**APPLICATION FOR WAIVER**

To Howard Co Code Subtitle 8: Onsite Sewage Disposal Systems and Subtitle 9: Individual Potable Water Supply Systems

Property Address: 12325 Fox Meadow Ln

Re: **Building Permit #B23004953**  
**12325 Fox Meadow Lane**  
**West Friendship, MD 21794**

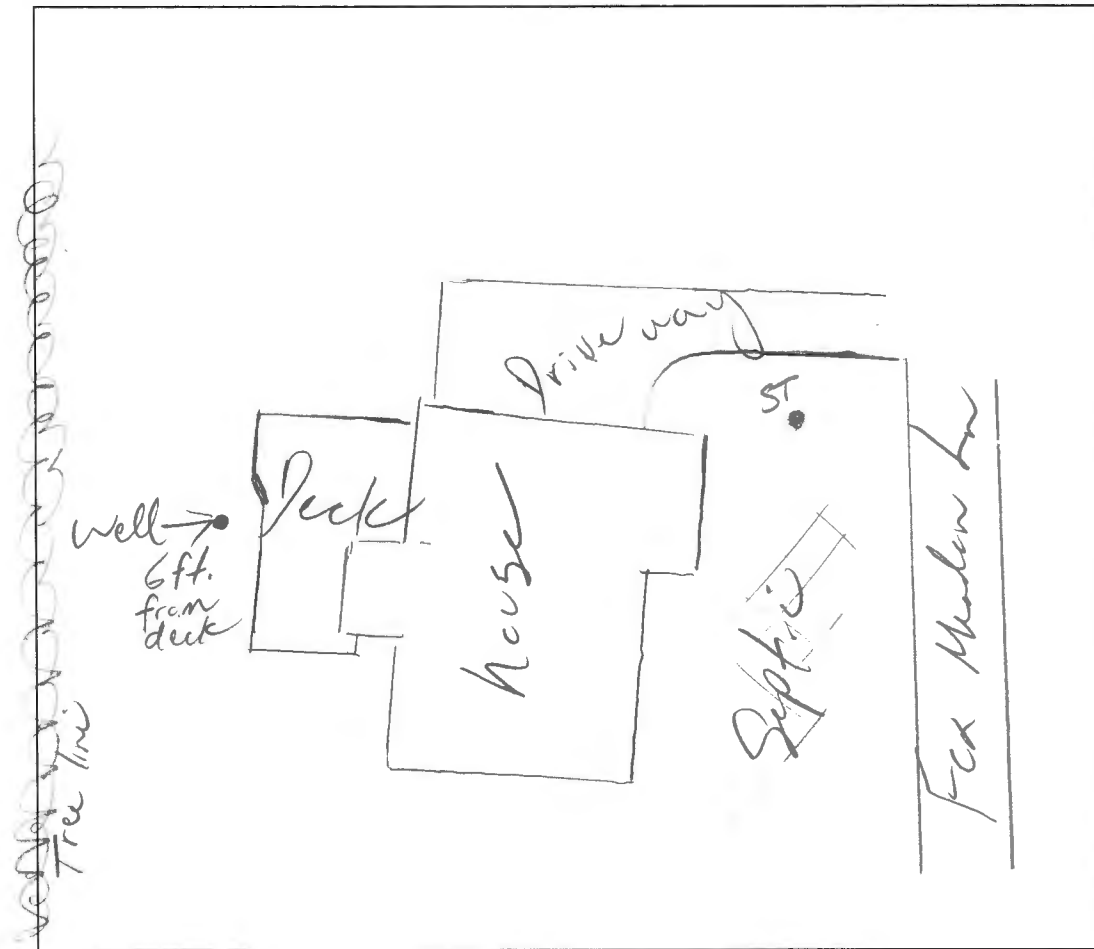
We would like to request a variance to allow a screen porch on pair footings to be closer then the required 10' setback to the property's well.

There will be (3) footings along the front wall of the porch. (2) of them will be located 3' from the well cap. They will be 30" deep, concrete in the bottom with a 6x6 post to support the room.

Comments/Conditions: Install footing 3' from well as shown on plot plan

*approved  
Gue  
2/13/24*

**LOCATION DIAGRAM**

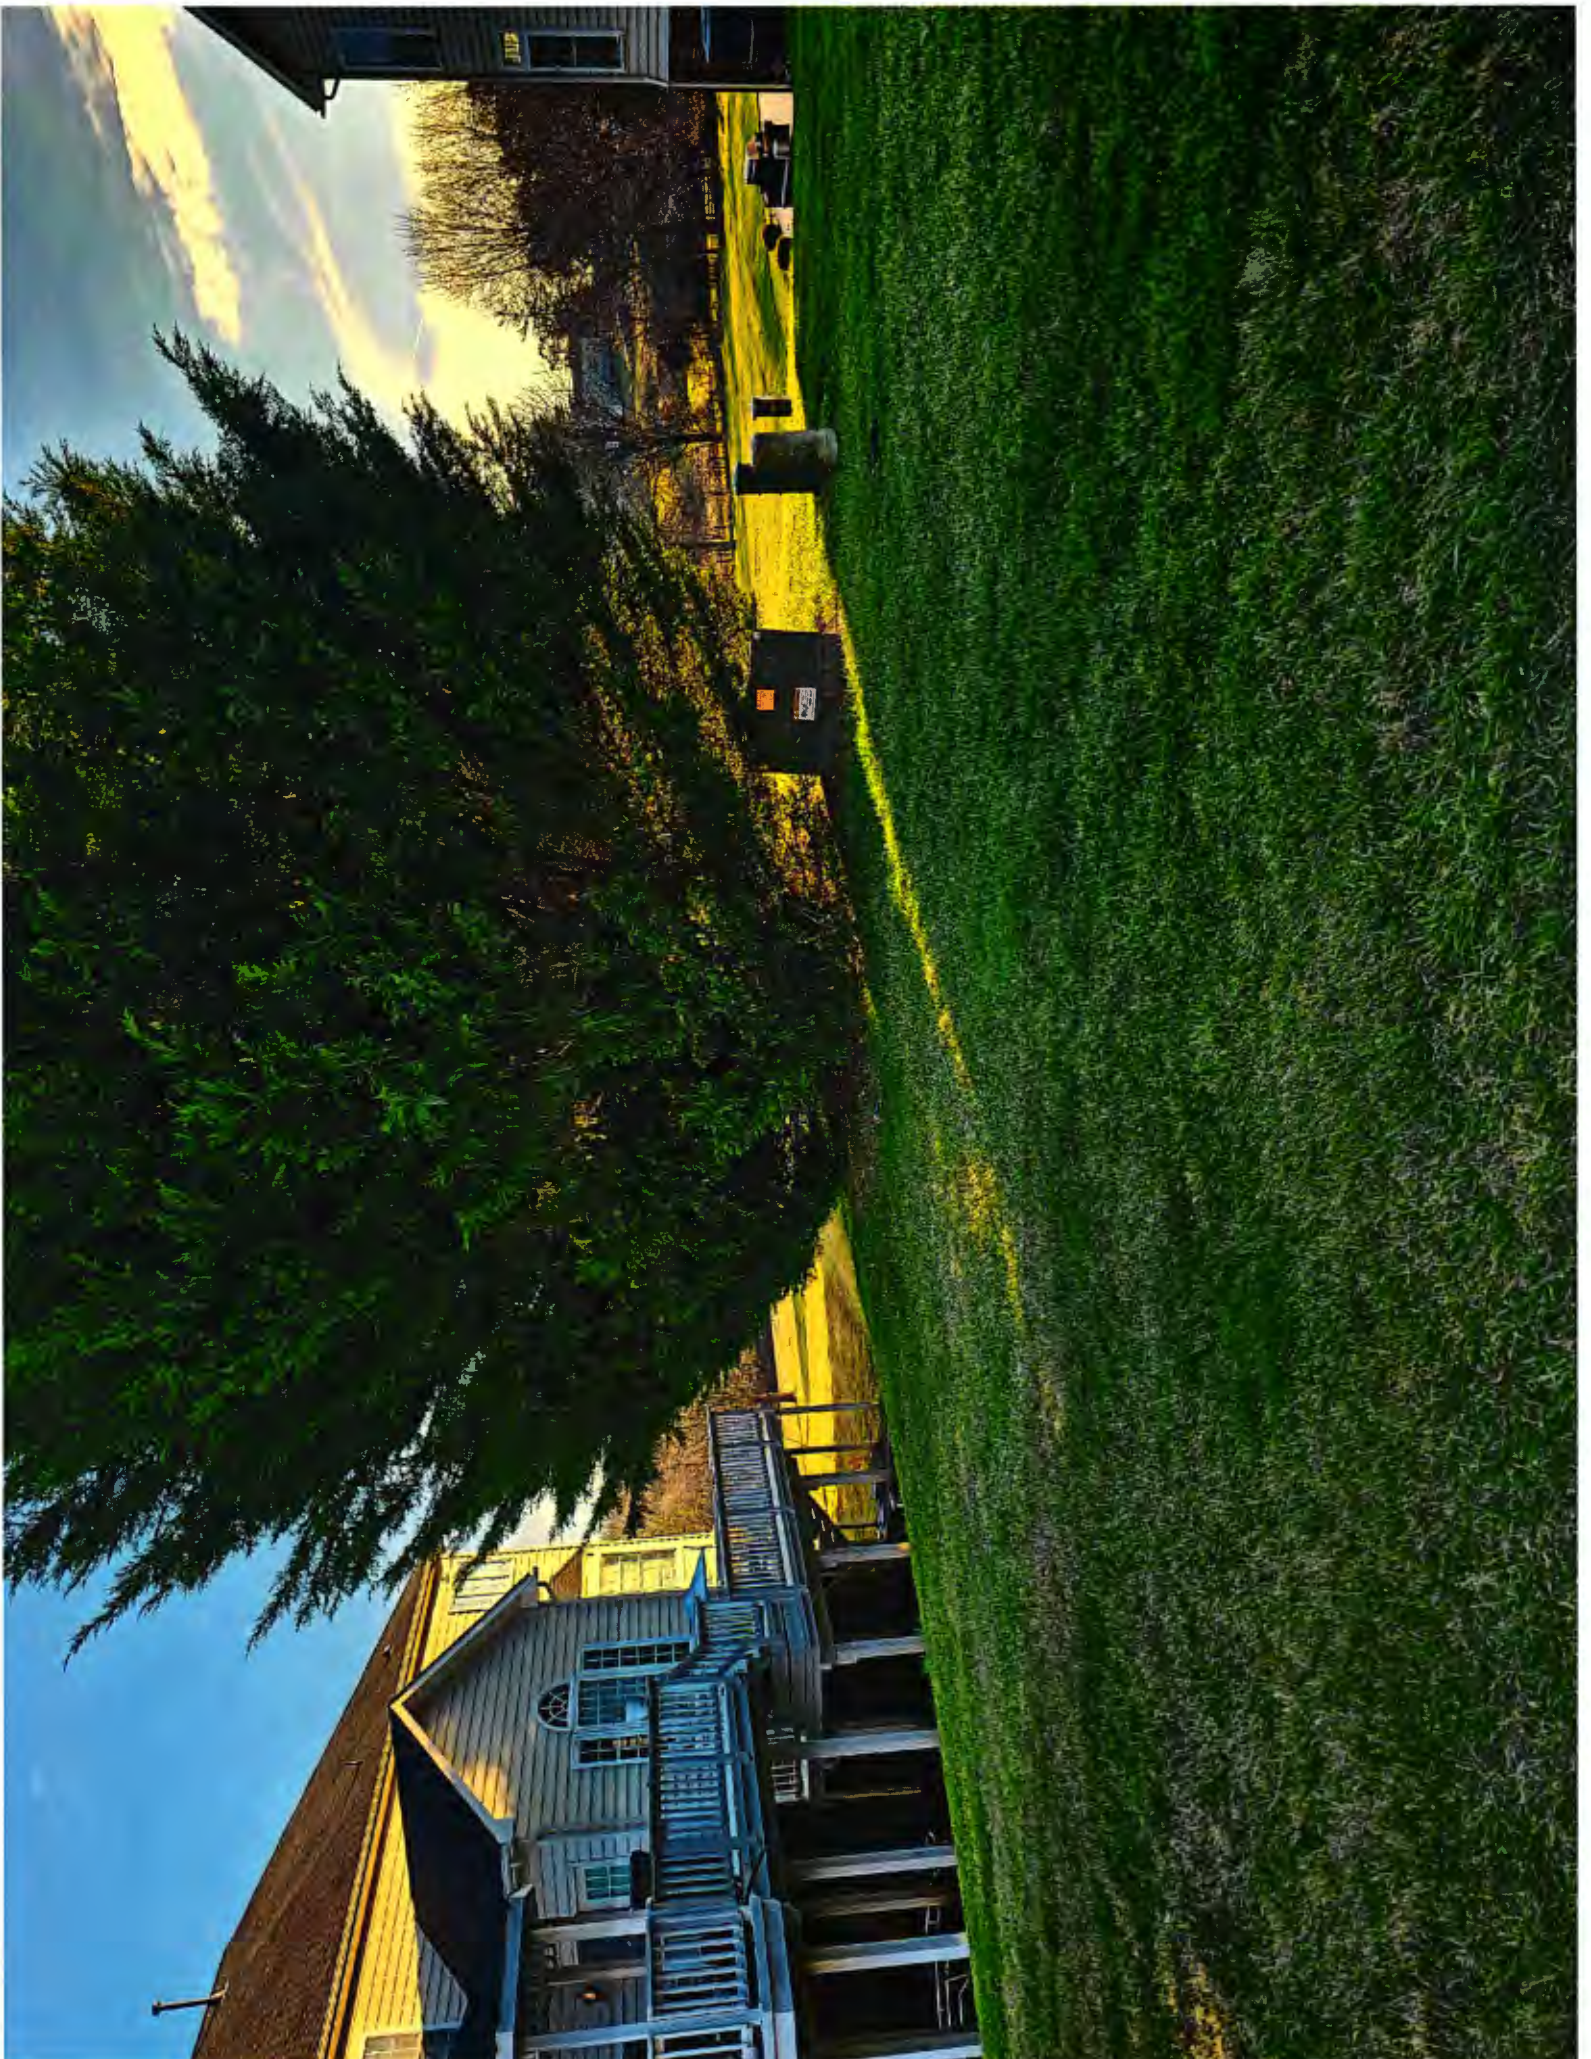
COMMENTS: No signs of hydraulic failure w/ septic.  
The well is 6ft from existing deck. Condition  
of the well is okay. Not currently 3ft  
from house.

01 PROPOSED DECK  
A-1 SCALE: 1/4" = 1'-0"

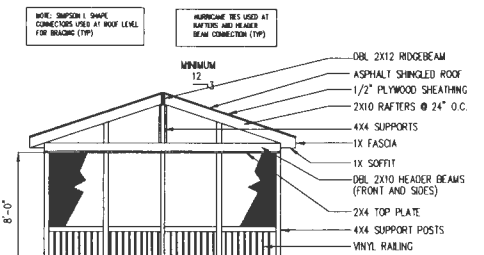
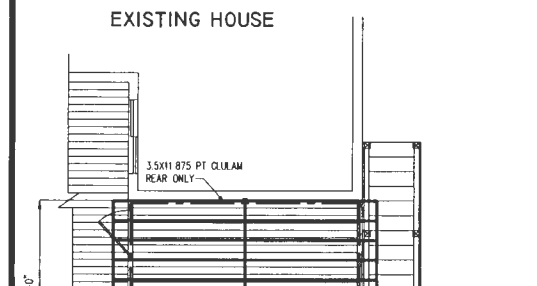
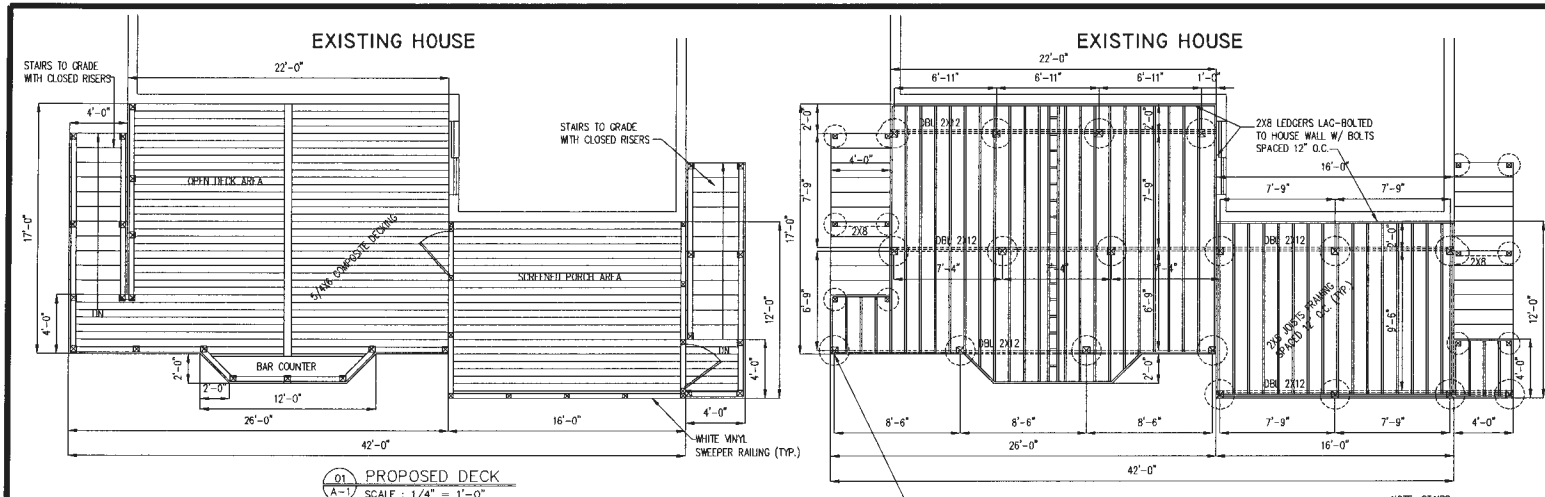
According to Howard County Code, a potable well must be positioned 10 feet away from a deck; however, your plot plan indicates an incorrect distance of 30 feet. After making a site visit to the property, the well location was measured to be 6 ft. away from the existing deck. Additionally, the new deck proposal would put the well 3 feet closer and the setback of 10 ft. is the minimum required to ensure groundwater protection and stability to your well casing/bore hole.

1. Submit a new deck proposal showing the minimum setback to align with Howard County Code.
2. Apply for a waiver from the requirements of Howard County Code. If pursuing this option, your waiver request letter should specifically address the 3 feet proximity to the well instead of the mandated 10 feet. Ensure that your waiver submission includes an accurate plot plan for our comprehensive review.
